MEADOWBROOK PARK

CIVIL CONSTRUCTION DOCUMENTS

PCD FILING NO. SF-21-025

MEADOWBROOK PARKWAY AND PREBLE DRIVE CURB RAMP DETAILS*

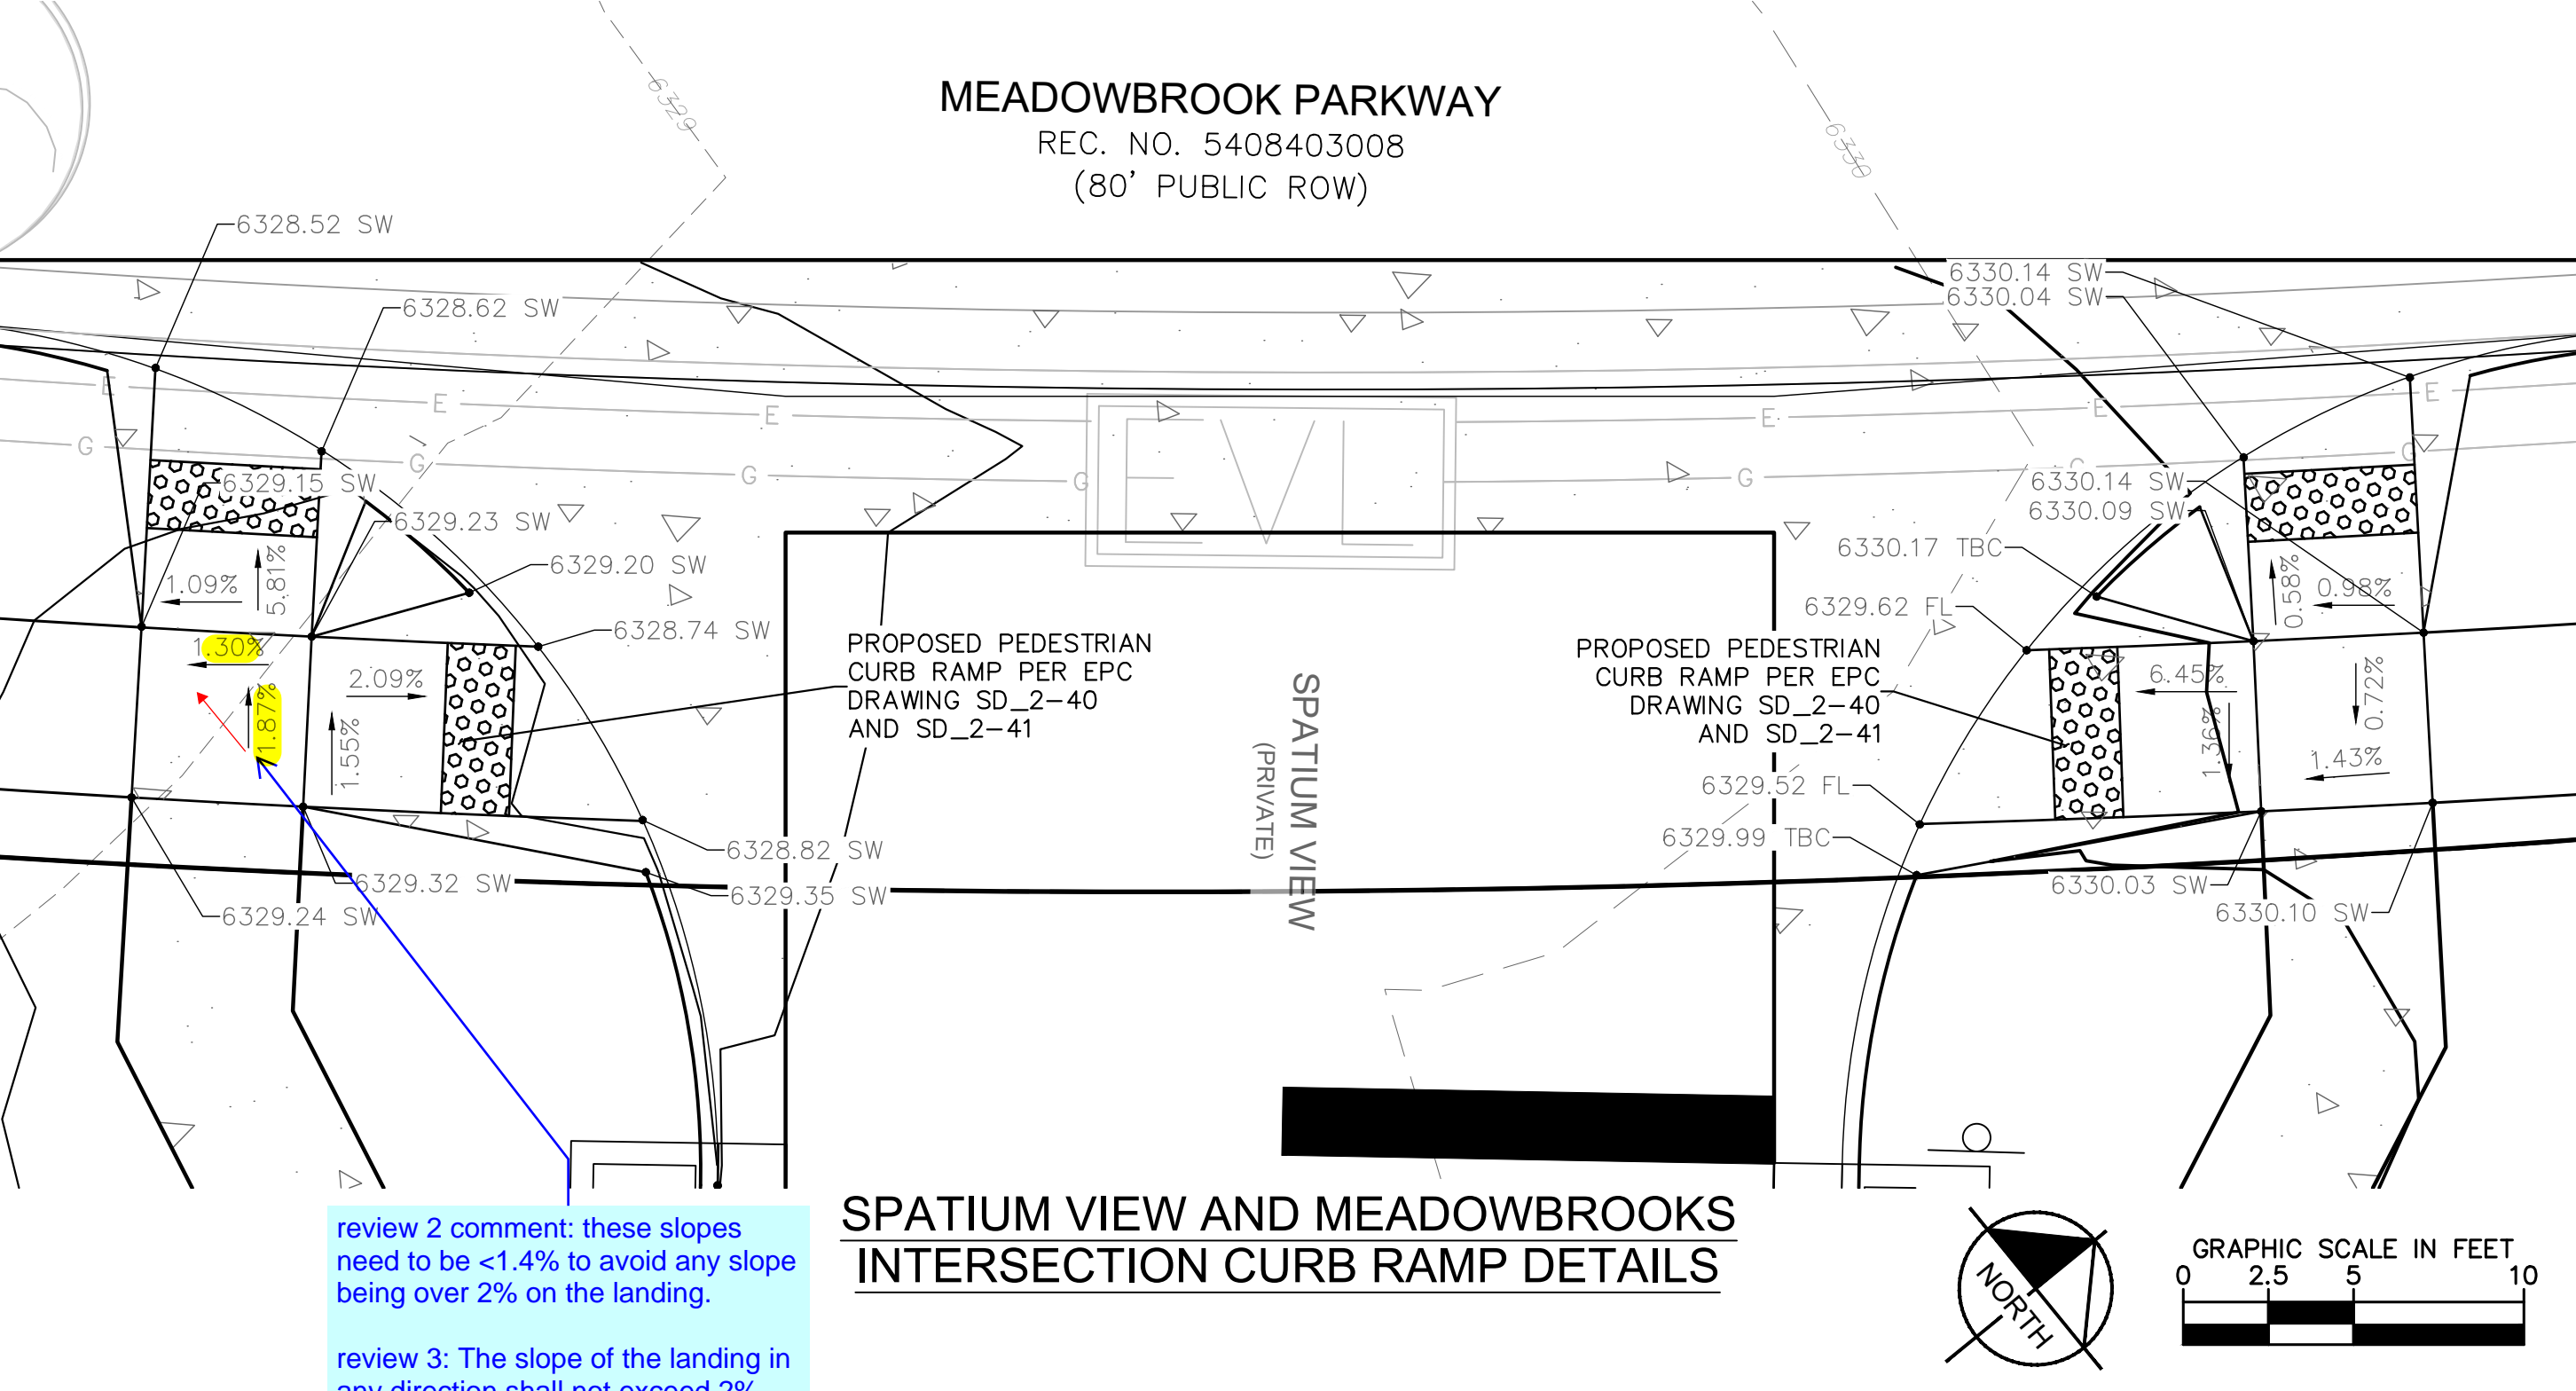
review 2 comment: these slopes need to be <1.4% to avoid any slope being over 2% on the landing.

review 3: The slope of the landing in any direction shall not exceed 2% (ECM CH6.3.1.G.5). The slope from Elevation 6329.15 to 6329.32 will exceed 2%. Please revise the slopes so that the slope in any direction does not exceed 2%

Please also provide the ramp on the other side of Preble Drive.

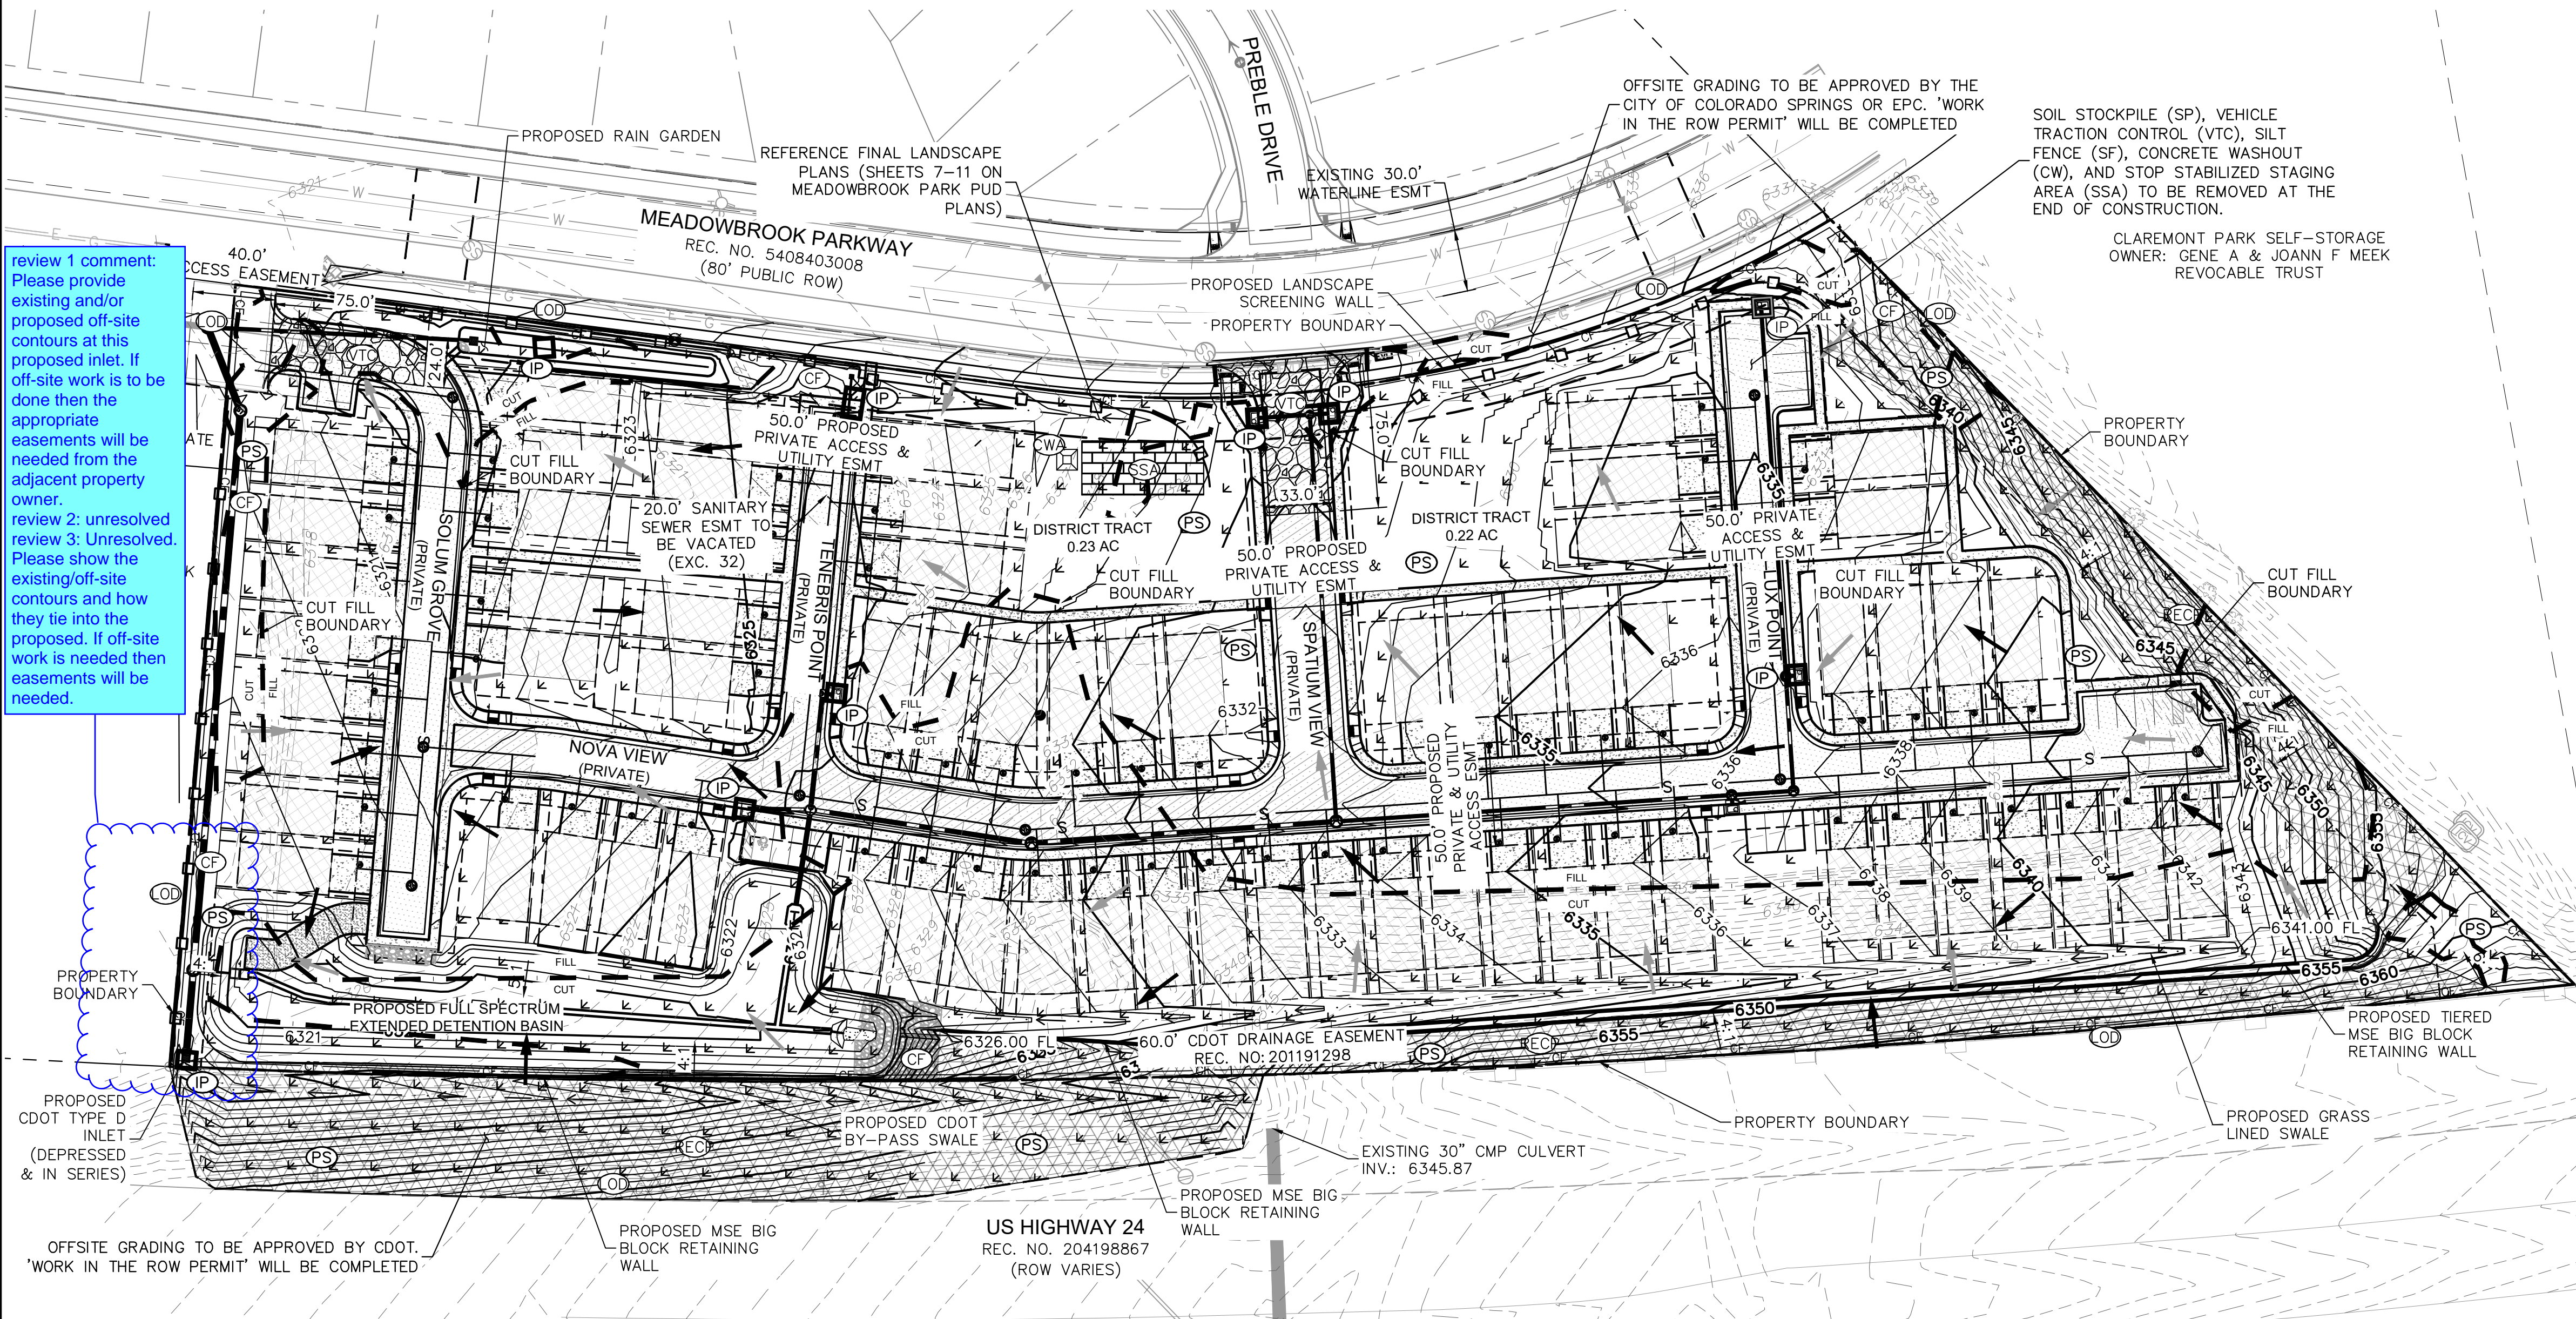
review 1 comment: Please provide existing and/or proposed off-site contours at this proposed inlet. If off-site work is to be done then the appropriate easements will be needed from the adjacent property owner.
review 2: unresolved
review 3: Unresolved. Please show the existing/off-site contours and how they tie into the proposed. If off-site work is needed then easements will be needed.

STORM SEWER LINE B PLAN VIEW

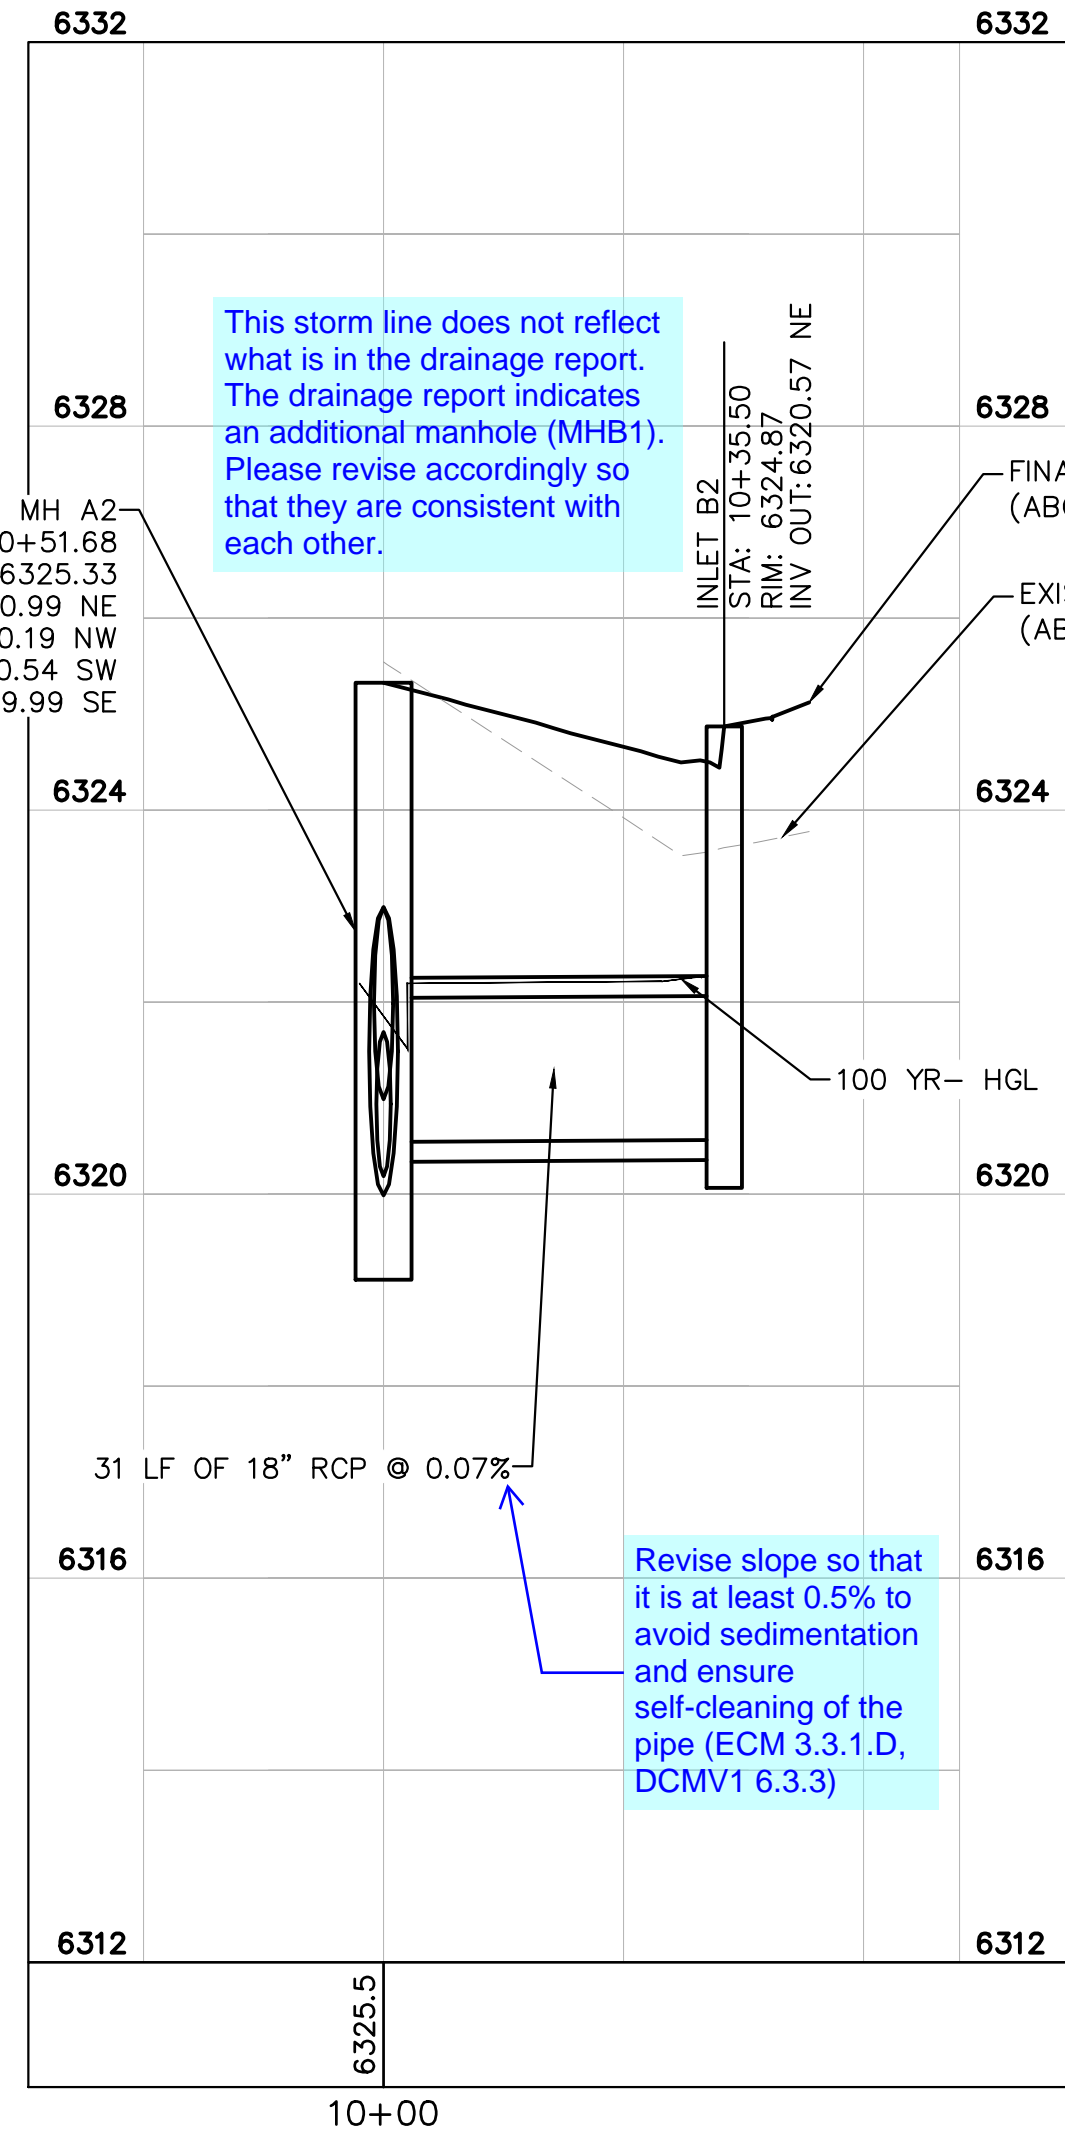
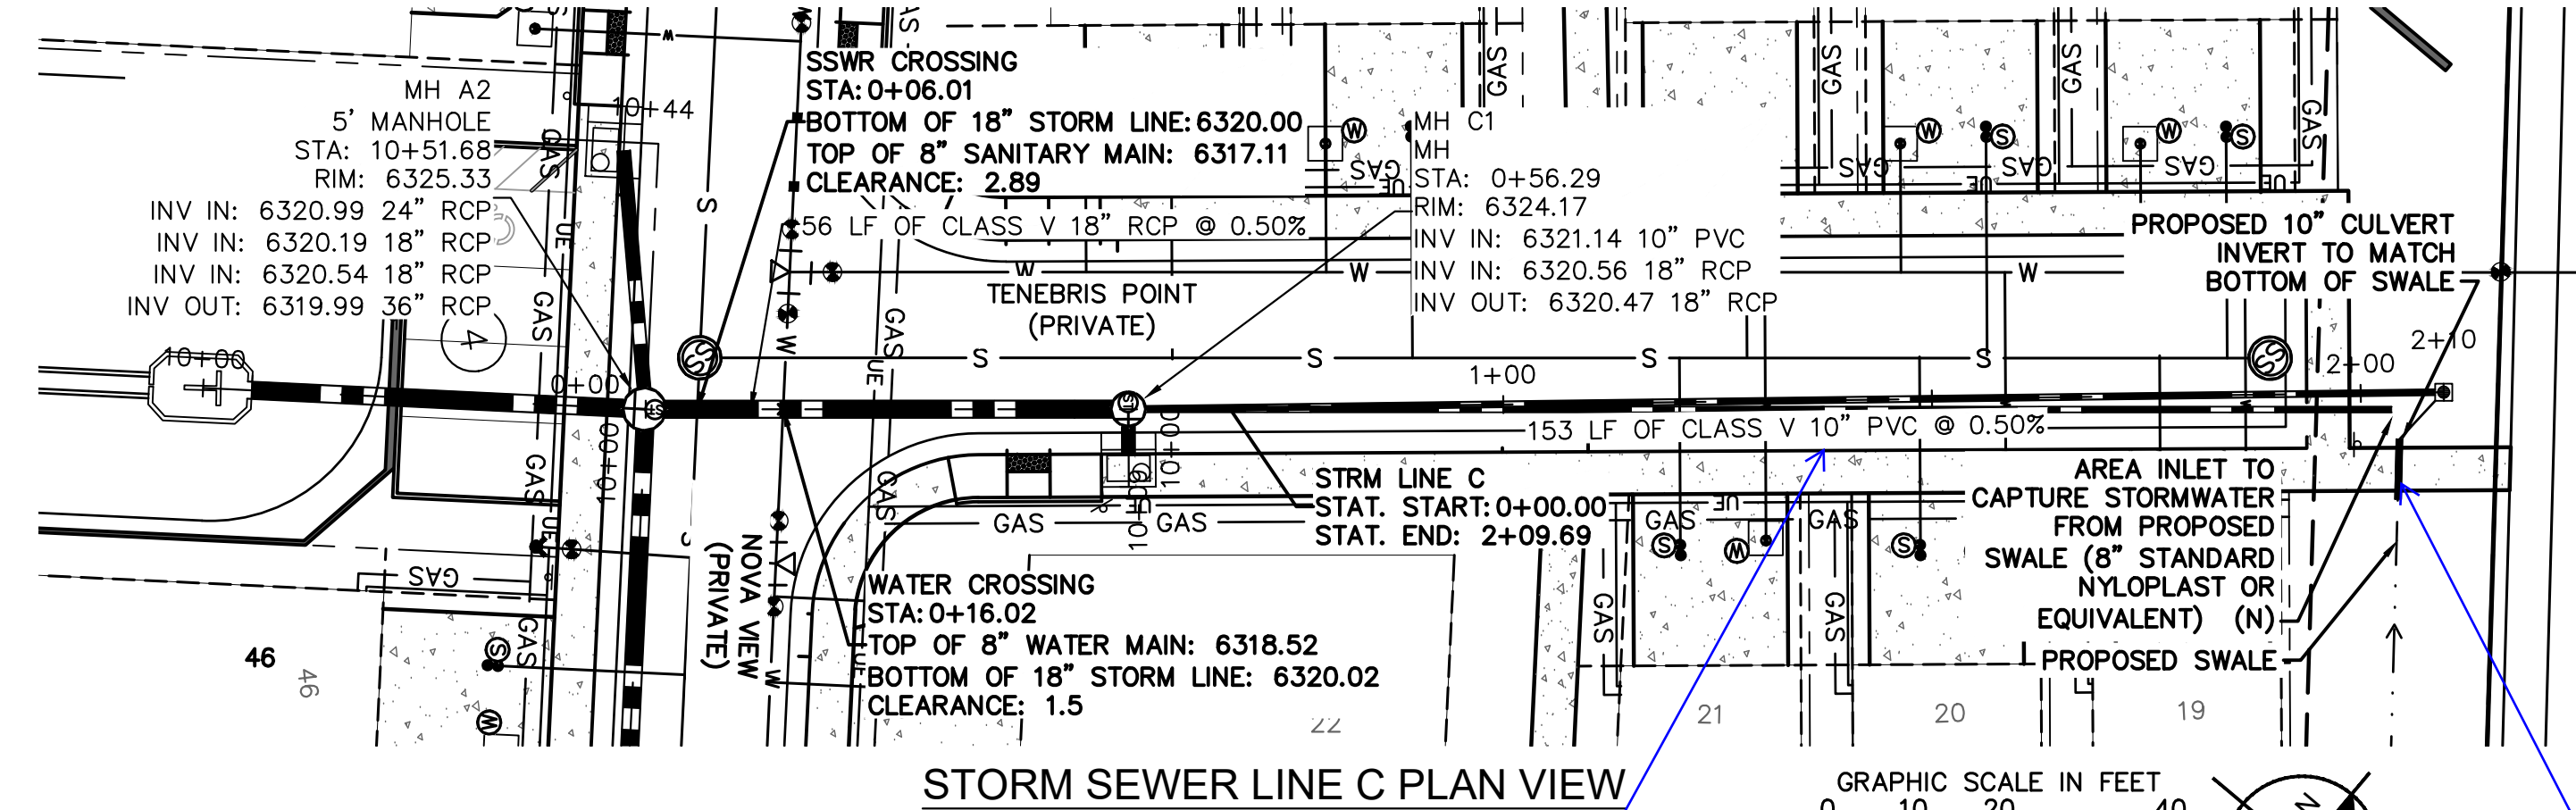
This storm line does not reflect what is in the drainage report. The drainage report indicates an additional manhole (MHB1). Please revise accordingly so that they are consistent with each other.

Revise slope so that it is at least 0.5% to avoid sedimentation and ensure self-cleaning of the pipe (ECM 3.3.1.D, DCMV1 6.3.3)
